ORDINANCE NO. \_\_\_\_\_

An ordinance amending Chapter 57, “Dallas One-and Two-Family Dwelling Code,” of the Dallas City Code, as amended; adopting with certain changes the 2015 Edition of the International Residential Code of the International Code Council, Inc.; regulating the construction, enlargement, alteration, repair, demolition, use, and maintenance of construction, plumbing, mechanical, and electrical work in the city on one- and two-family dwellings; providing a penalty not to exceed \$2,000; providing a saving clause; providing a severability clause; and providing an effective date.

SECTION 1. That Chapter 57, “Dallas One- and Two-Family Dwelling Code,” of the Dallas City Code, as amended, is amended by adopting the 2015 Edition of the International Residential Code of the International Code Council, Inc. (which is attached as Exhibit A and made a part of this ordinance), with the following amendments:

**“FIGURE R602.6.1  
TOP PLATE FRAMING TO ACCOMMODATE PIPING**

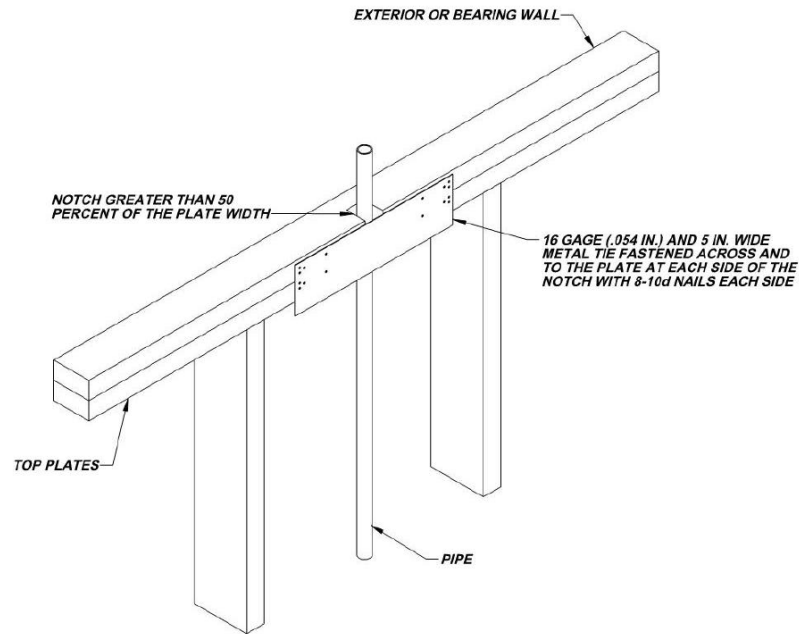
27. Figure R602.6.1, “Top Plate Framing to Accommodate Piping,” of Subsection R602.6, “Drilling and Notching of Studs,” of Section R602, “Wood Wall Framing,” of Chapter 6, “Wall Construction,” of the 2015 International Residential Code is deleted and replaced with a new Figure R602.6.1, “Top Plate Framing to Accommodate Piping,” to read as follows:

**“R602.6.1 Drilling and notching of top plate.** When piping or ductwork is placed in or partly in an exterior wall or interior load-bearing wall, necessitating cutting, drilling or notching of the top plate by more than 50 percent of its width, a galvanized metal tie not less than 0.054 inch thick (1.37 mm) (16 ga) and 5 [~~4~~/~~2~~] inches (127 [~~38~~] mm) wide shall be fastened across and to the plate at each side of the opening with not less than eight 10d (0.148 inch diameter) nails having a minimum length of 1 1/2 inches (38 mm) at each side or equivalent. Fasteners will be offset to prevent splitting of the top plate material. The metal tie must extend a minimum of 6 inches past the opening. See Figure R602.6.1.
